DRAINAGE PLAN FOR
B ELECTRIC
SAN FRANCISCO AVENUE N.E.
ALBUQUERQUE N.M.

REVISION #1 - DECEMBER 27, 1993

| CITY OF ALBUQUERQUE PUBLIC WORKS DEPARTMENT ENGINEERING GROUP | | | | | |
|---|--------------|------|--------------|----------|------|
| TITLE: DRAINAGE PLAN FOR 6000 SAN FRANCISCO N.E., ALB., N.M. | | | | | |

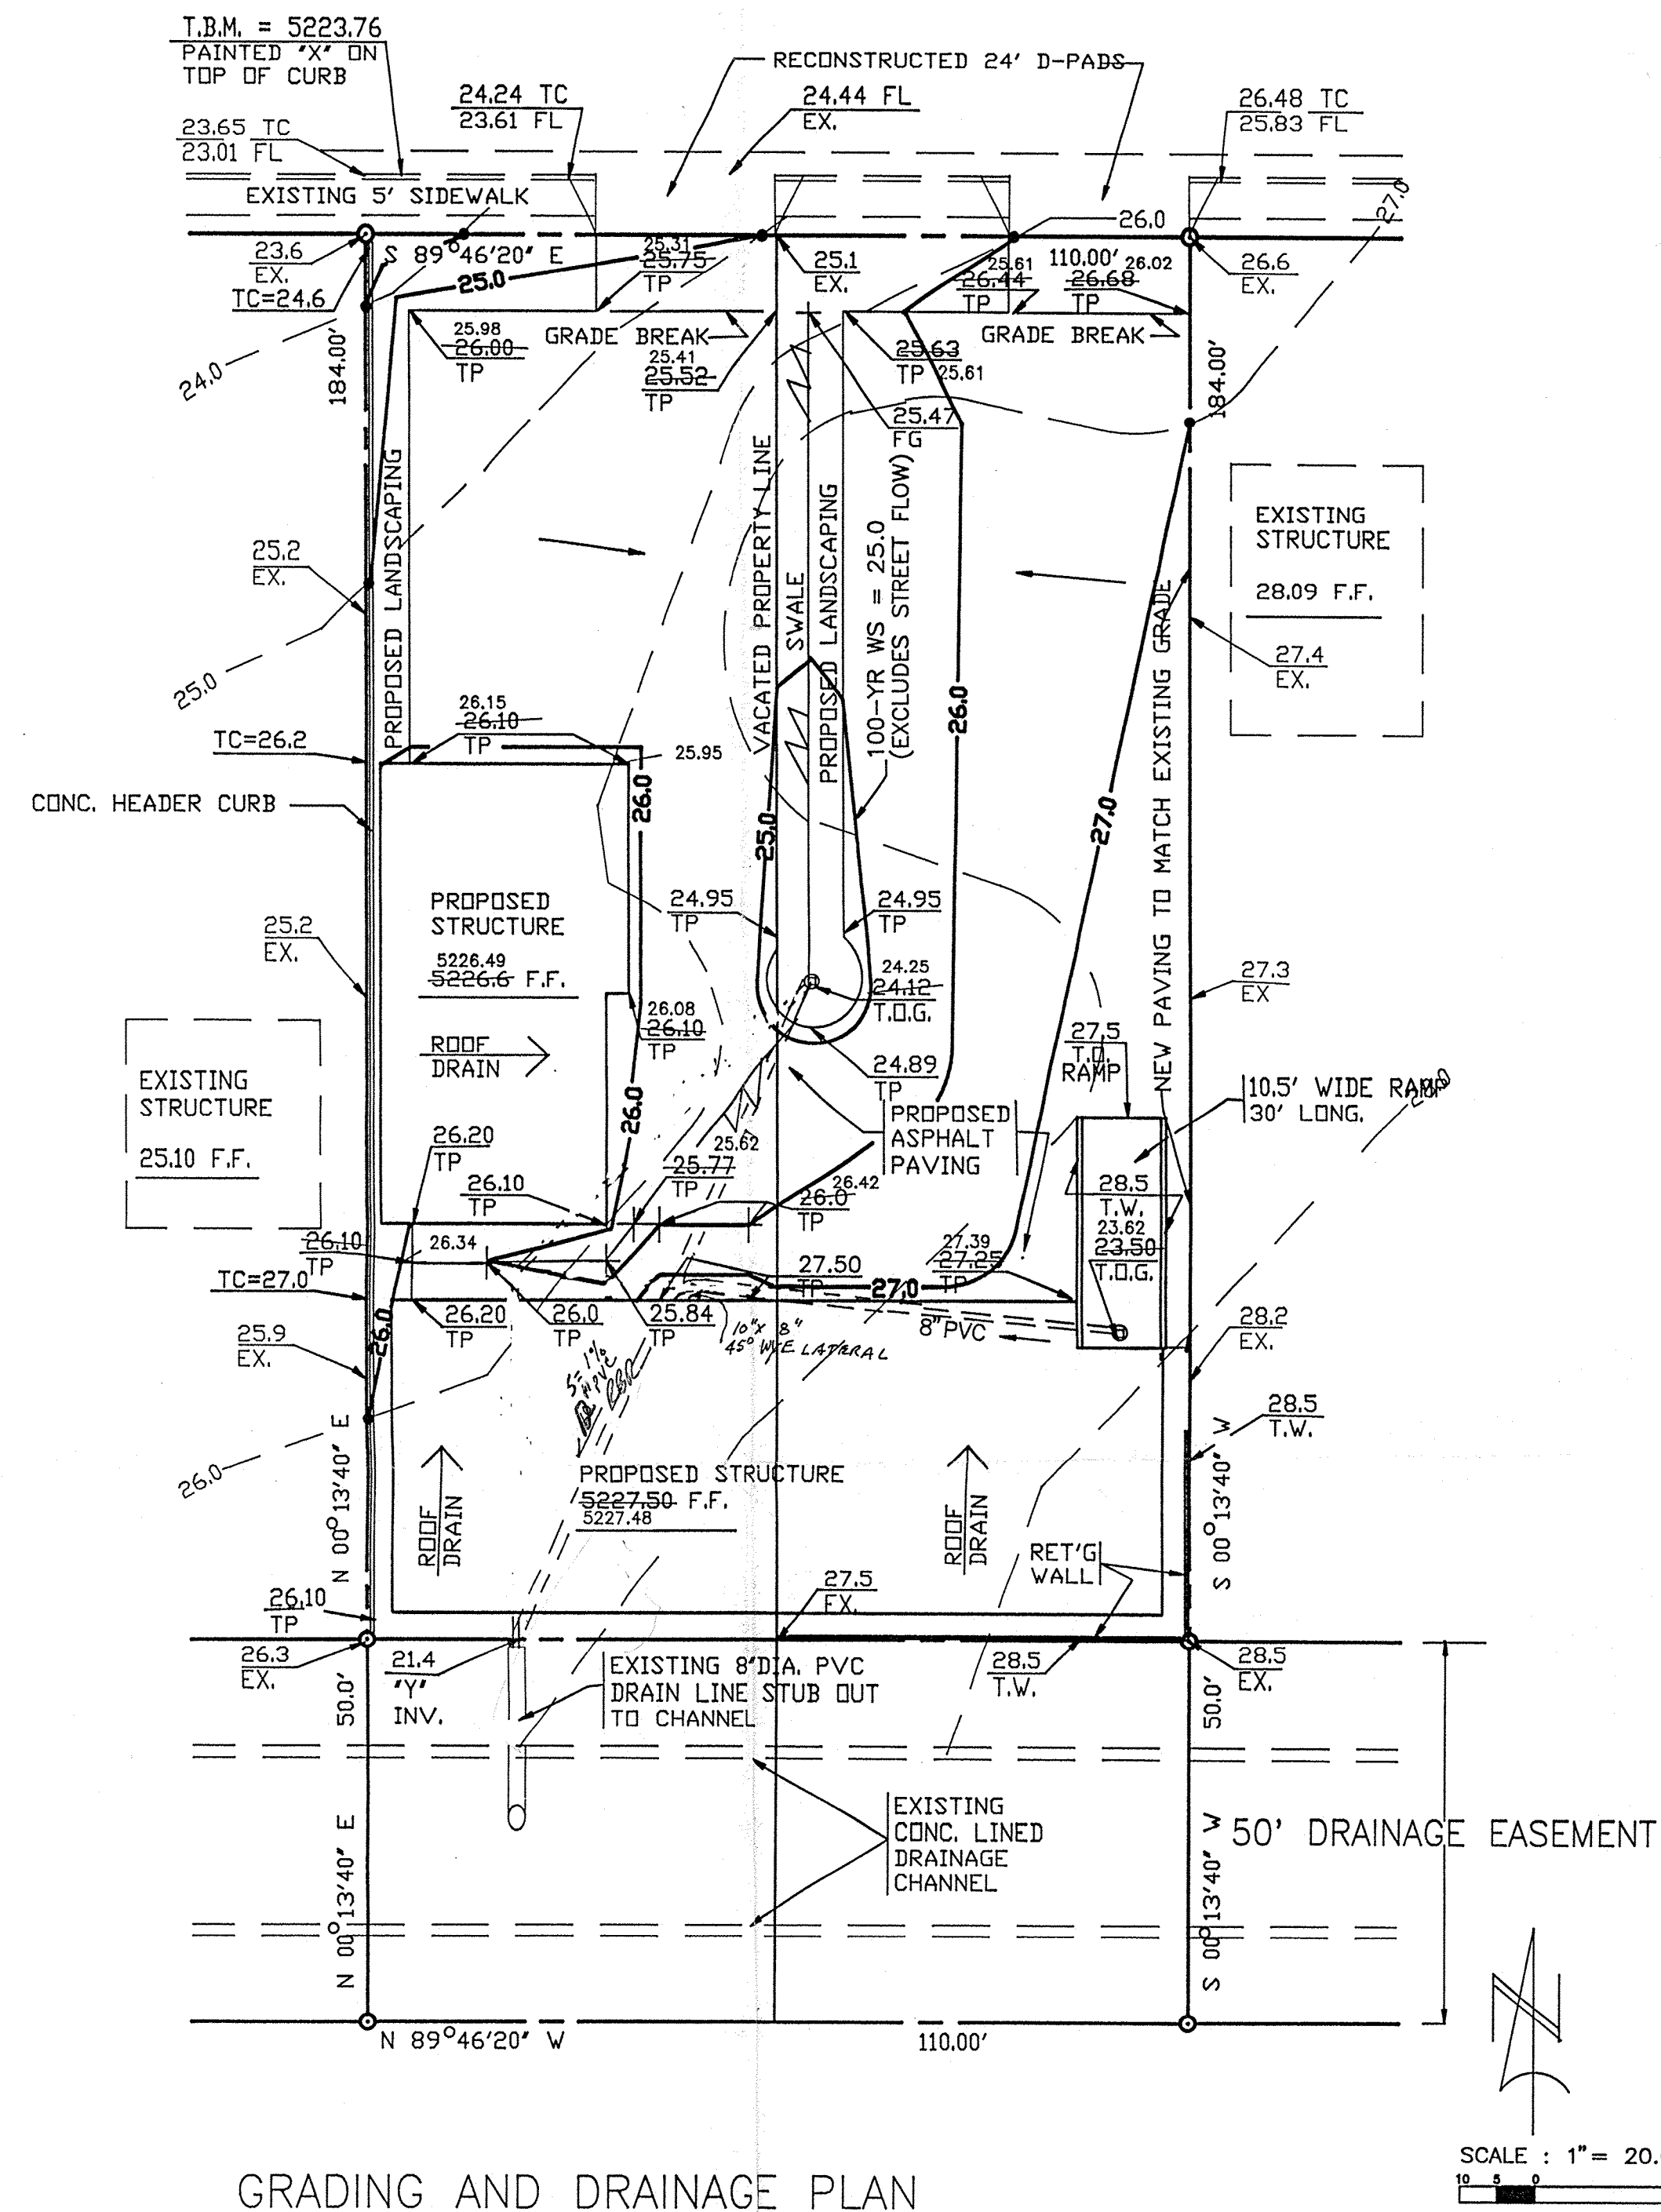
THIS REVISION HAS BEEN REQUIRED DUE TO CHANGE IN WAREHOUSE BUILDING SIZE FROM THAT SHOWN ON THE APPROVED PLAN STAMPED 7-16-93. THIS CHANGE DOES NOT INCREASE RUNOFF VOLUMES OR PEAK DISCHARGE NOR DOES IT SIGNIFICANTLY CHANGE PREVIOUSLY APPROVED GRADES.
